Site Plan Appeal

1106 Lambie Street (SP-2013-0484 C) Water Front Planning Advisory Board
June 10, 2014

WATERFRONT PLANNING ADVISORY BOARD
STAFF REPORT

CASE: 1106 Lambie Street (SP-2013-0484C)

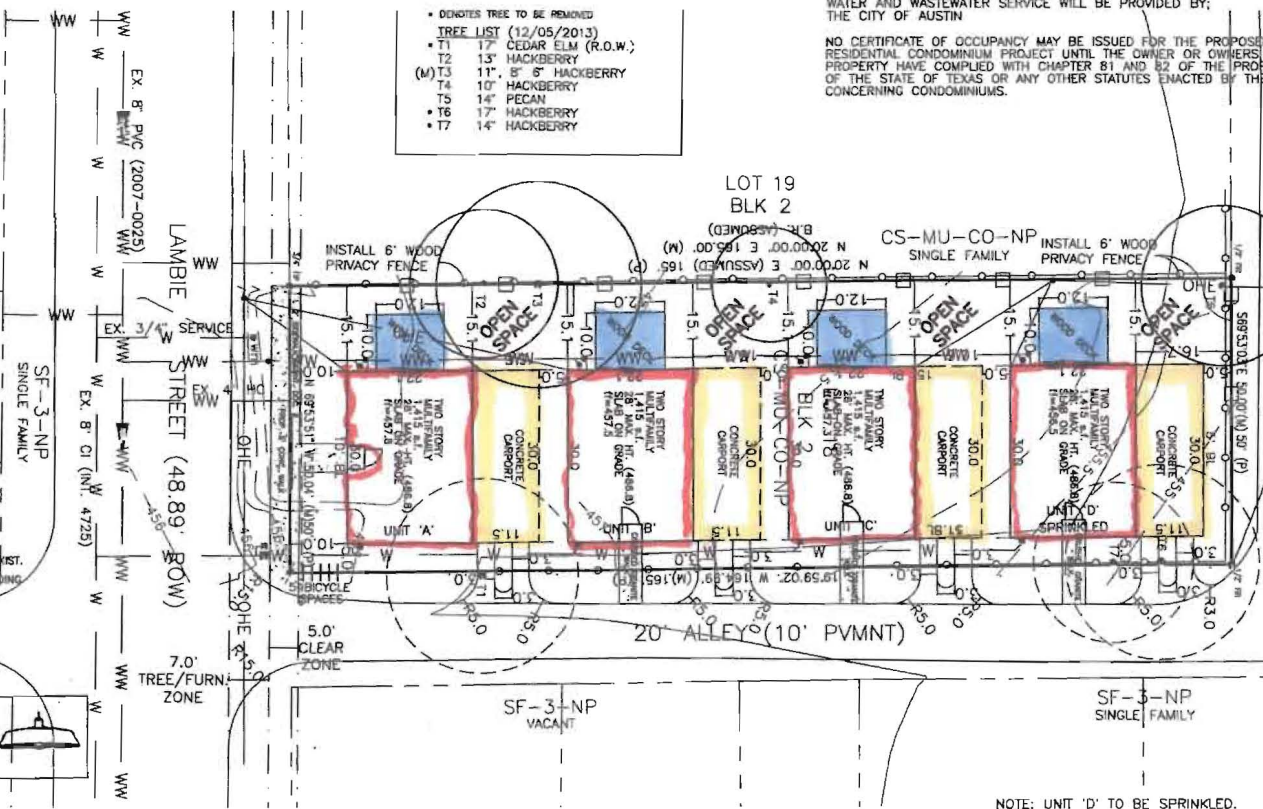
The major feature driving the increased impervious cover increase is the read uncovered decks. The developer wants to make these small urban homes attractive to families by adding this amenity.
